Subject: Safety Inspection of Wentworth Road Dam, Plantagenat Lot 303

Thank you for the opportunity to undertake a limited review of safety aspects of your water storage dam, located on the western side of Wentworth Road on Raintree Farm.

Red Earth Engineering Pty Ltd (REE) provides the following letter report to address the issues that you raised during our meeting and site inspection on the 3rd of August 2010 that was attended by Don Glenister. This review is limited to visible site conditions and by information provided by Mr Birkbeck and Mr Nigel Palmer, the earthworks contractor. A limited site survey was undertaken and an assessment made of the dam's hydrology and the hydraulic capacity of the dam spillway structures.

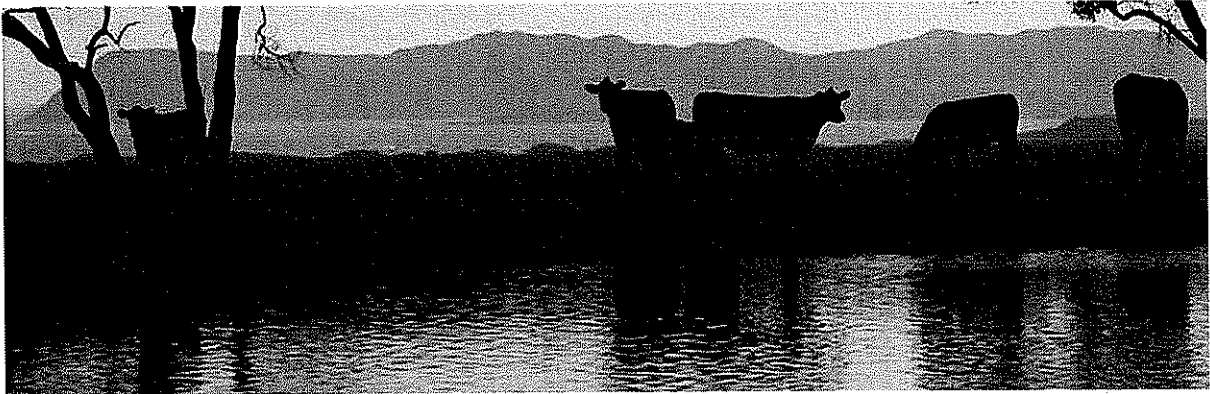
1. The upstream face of the dam, and to a lesser extent the northern return embankment, is subject to wave erosion. It is recommended that a 300mm thick capstone rubble and rock (up to 300mm in size) layer be placed on the embankment face between RL 75 and 77 to protect the slope against wave erosion when the dam is full. It may be possible to place this 'rip-rap' during later summer when the dam level is at its lowest to minimise disturbance to the landscaping that has been installed along the crest. It is possible that placement of further

2. Additional compacted gravel and rubble fill should be added to the top section of the eastern abutment of the emergency spillway to avoid overtopping in the event of storm discharge from the two emergency spillway structures. It is suggested that this section be built up by 300mm. (Refer photograph 6/080810)

3. Further use of the grey/white silty material that has been used to sheet the inside slopes of the dam should be avoided as the material is highly erodible.
